THE CHILDREN'S HOSPITAL AT WESTMEAD Paediatric Services Building

AMENDED LANDSCAPE REPORT

Response to Submssion - Landscape Design

CHW PAEDIATRIC SERVICES BUILDING LANDSCAPE SSDA REPORT

PSB Lv 02 PLAN

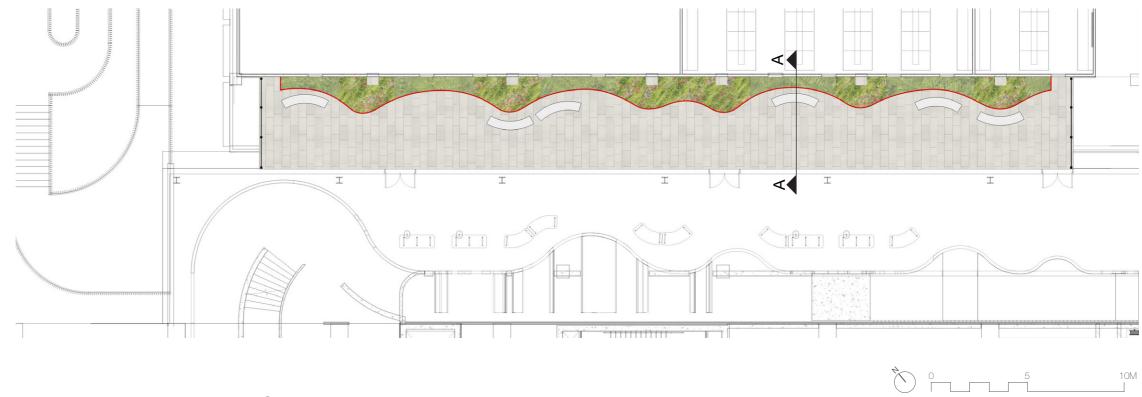
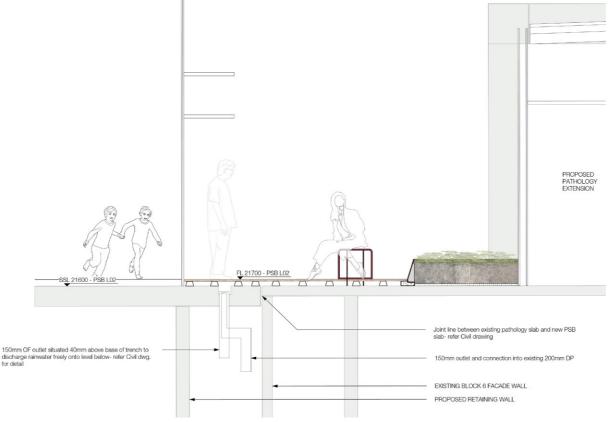
SSDA Submission Comments	Response				
DPIE					
Updated landscape plans are to be submitted providing:					
Further detail of the aboriginal garden and its integration with the Kidsway	The Aboriginal garden is located adjacent the main entrance to the PSB and adjacent the internal meeting room for the Aboriginal community. The detailed design of the garden will be undertaken in collaboration with Aboriginal stakeholders. Refer updated Kidspark concept plans in section 6.0 for revised location.				
Details of the outdoor levels and enclosed outdoor level landscaped areas and their treatment and access arrangements.	A range of updates have been made to the enclosed and outdoor landscaped areas across the floors of the PSB. Please refer to plans and descriptions provided in section 6.0 of this report.				
Confirmation of the maintenance measures in place for the landscaped levels within the PSB, particularly, if they are enclosed and for viewing purposes only.	Access for maintenance will be provided to all landscaped areas from the adjacent internal spaces to avoid the need for complex maintenance regimes that require abeiling etc. Balustrades are provided to all landscaped areas where required by BCA.

Level 2 Kidsway is intended to become a space that blurs the boundary between inside and out. A continuous glazing line runs the length of the space however the pavement will continue from inside to out [with appropriate surface treatment to meet slip reseistance requirements] to create a sense of unity.

The space is located over an existing slab that has loading limitations, so the extent of planting and greening is limited by reduced soil depths, however hardy species will be utilised to green the space as much as practical .
